Re: Special Permit  
107 Eastern Boulevard, Glastonbury, CT

We are in receipt of your memorandum dated April 15, 2021, regarding the project noted above. Our responses regarding the traffic study comments are indicated below in ***bold italic*** text and are as follows:

## Estimation of Net Vehicles on Site: Average Weekday without Flex

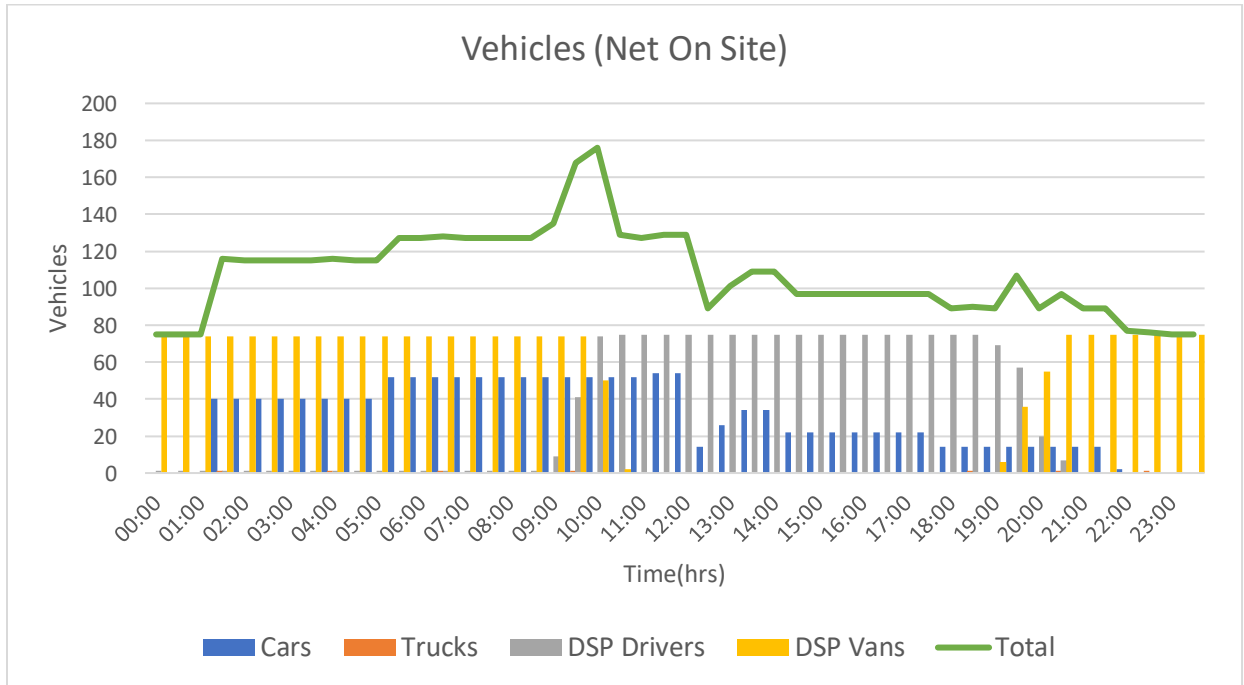
- C. The applicant is asked to provide further detail to justify the proposed level of parking on the site. Said request applies to both the standard 9’ x 18’ stall count and the larger 11’ x 27’ stall count. Information provided to date has not sufficiently explained the proposed parking need.

- G. The Applicant is asked to provide comment for Commission consideration regarding any substantive seasonal variations with respect to site trips generated from the facility. The month of December is of particular interest with respect to this issue.

**Response: Acknowledged. Please see the chart below and graph at the end of this document. This data shows the anticipated employees at this facility. As you can see from the duration of the shifts that there is significant overlap that necessitates the parking lot. The largest overlap is from employees showing up earlier for the 2<sup>nd</sup> shift with the C0 shift is finishing their day**

***Response: Please see the attached graph showing the seasonal variation related to the proposed development operations.***
